Dominion Nuclear Connecticut, Inc.  
Millstone Power Station  
Rope Ferry Road  
Waterford, CT 06385

Millstone Power Station, Unit No. 2  
Technical Specifications Change Request (TSCR) 2-10-01  
Fuel Pool Requirements

Technical Specification Change Request (TSCR) 2-10-01  
Fuel Pool Requirements  
Discussion of Proposed Changes and Safety Summary

FIGURE 3.9-1B MINIMUM REQUIRED FUEL ASSEMBLY EXPOSURE AS A FUNCTION OF INITIAL ENRICHMENT TO PERMIT STORAGE IN REGION C WITH POISON PINS INSTALLED

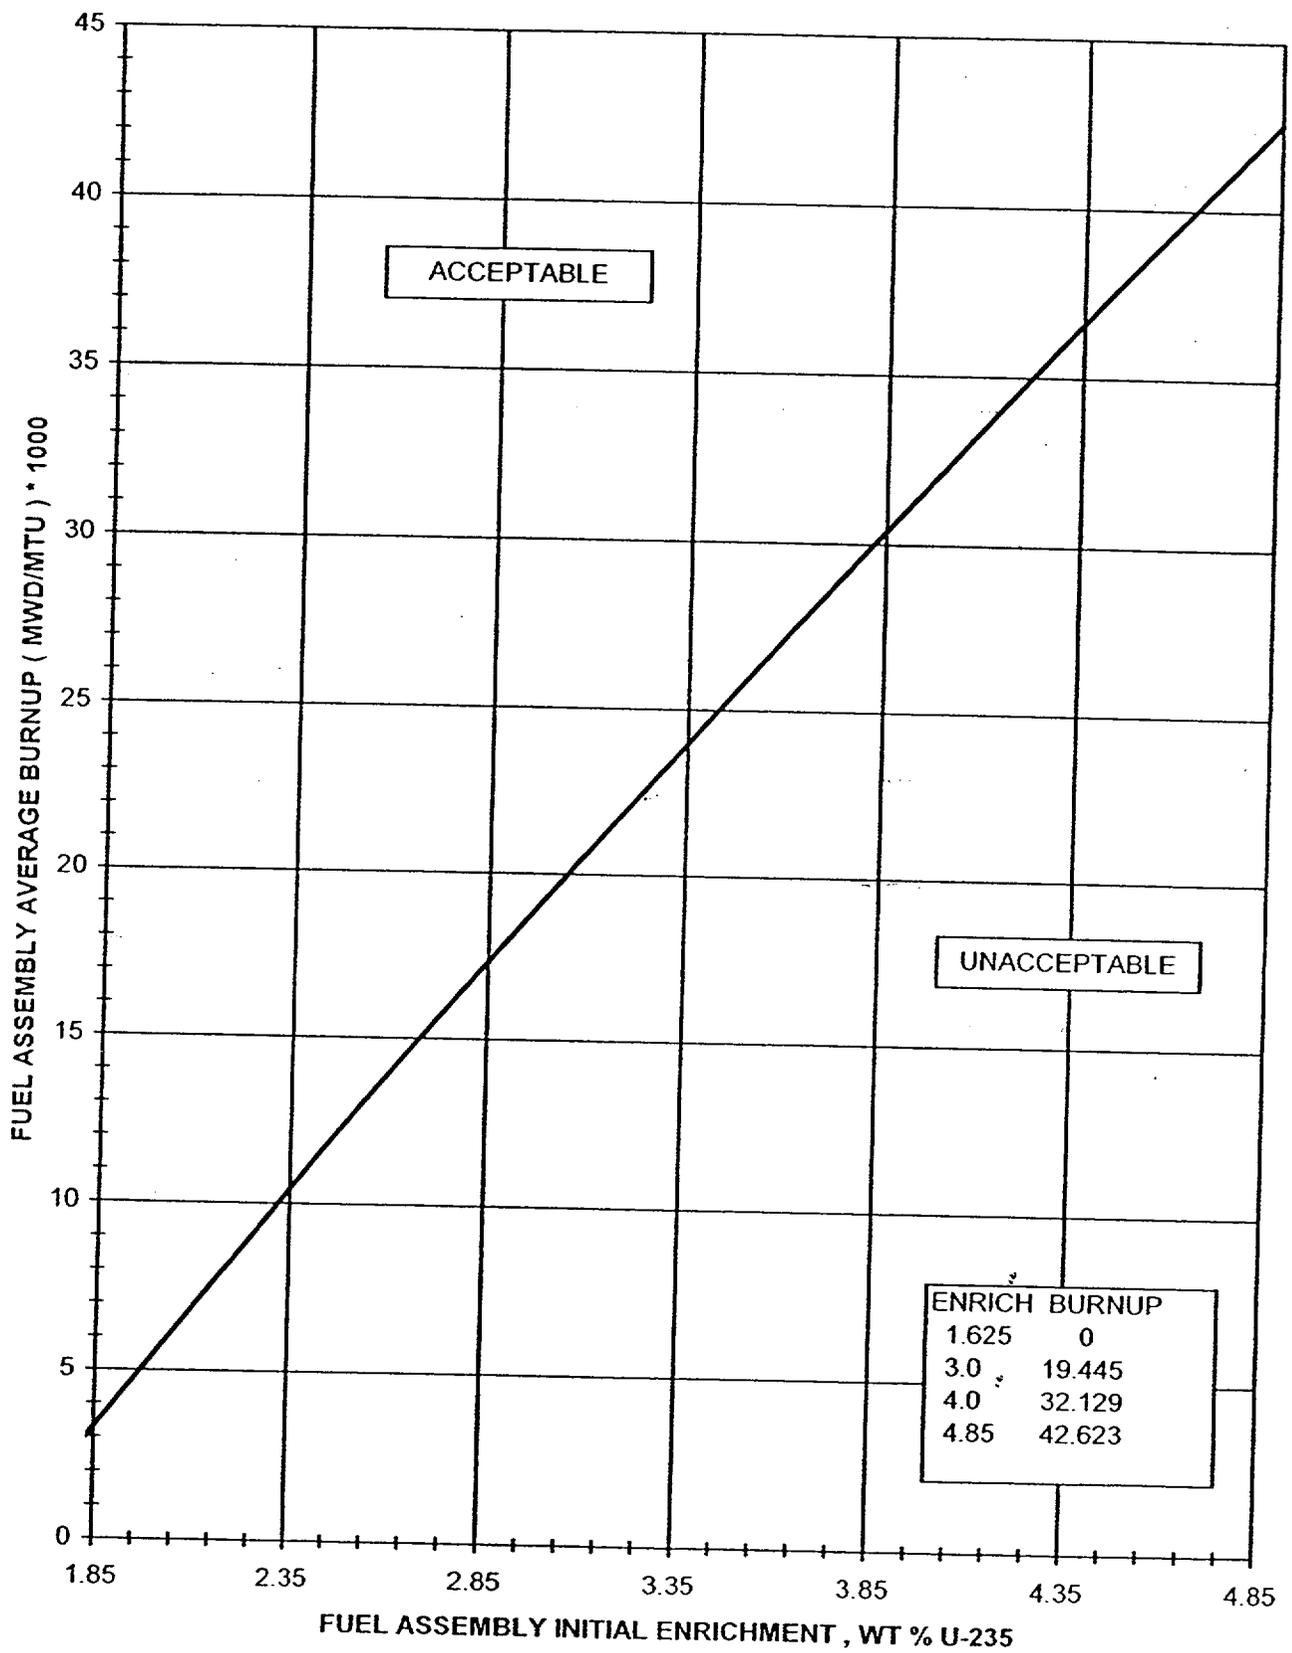
This TS figure shows the minimum required fuel assembly exposure as a function of initial enrichment to permit storage of fuel assemblies in Region C, with poison pins installed. This TS figure is revised to reflect the revised criticality analysis.

The values shown in this Figure are taken from the criticality analysis that is attached. The required burnups shown in the proposed Figure 3.9-1B are slightly smaller than the current limits due to soluble boron credit.

Replace with new Figure 3.9-1B

FIGURE 3.9-4 MINIMUM REQUIRED FUEL ASSEMBLY EXPOSURE AS A FUNCTION OF INITIAL ENRICHMENT TO PERMIT STORAGE IN REGION A

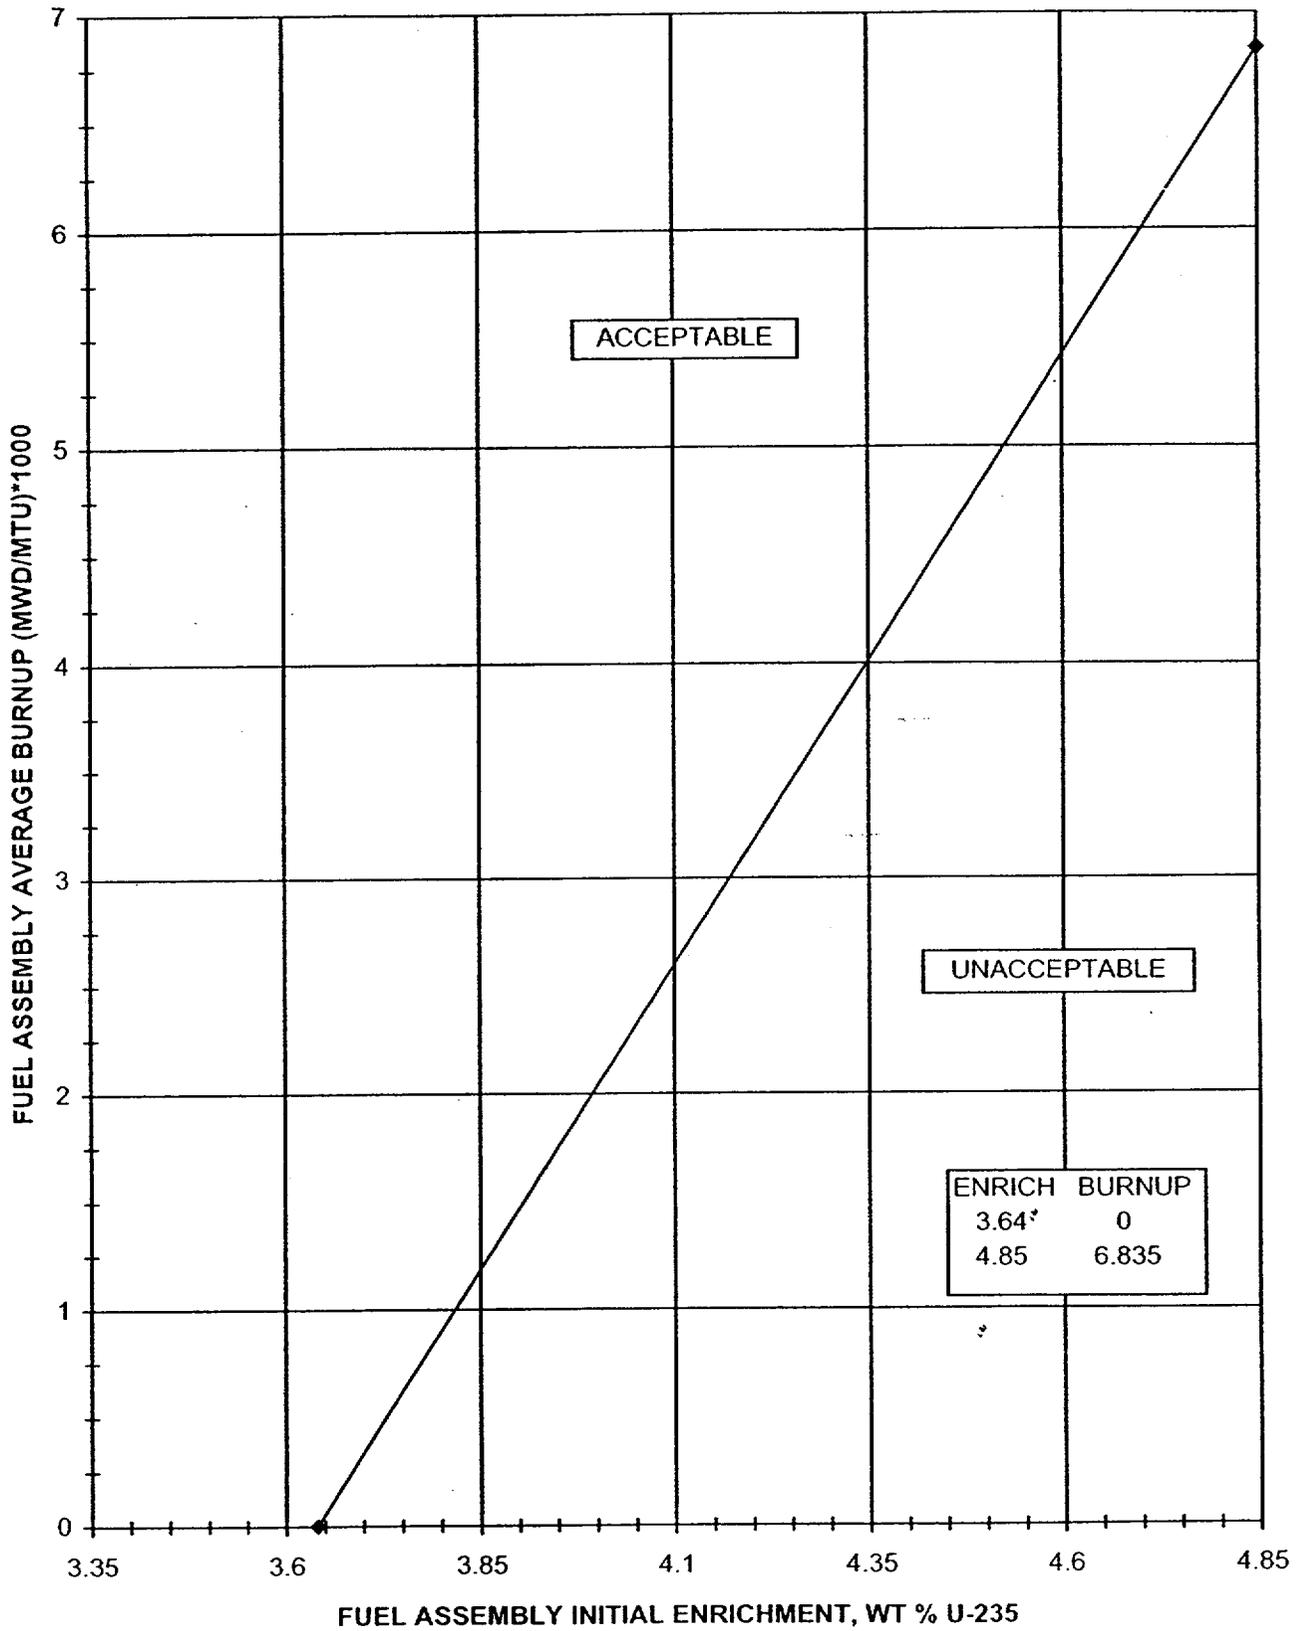
This TS Figure shows the minimum required fuel assembly exposure as a function of initial enrichment to permit storage of fuel assemblies in Region A. This TS figure is revised to reflect the revised criticality analysis.

The values shown in this Figure are taken from the criticality analysis that is attached. The required burnups shown in the proposed Figure 3.9-4 are slightly smaller than the current limits due to soluble boron credit.

*Replace with new Figure 3.9-4*
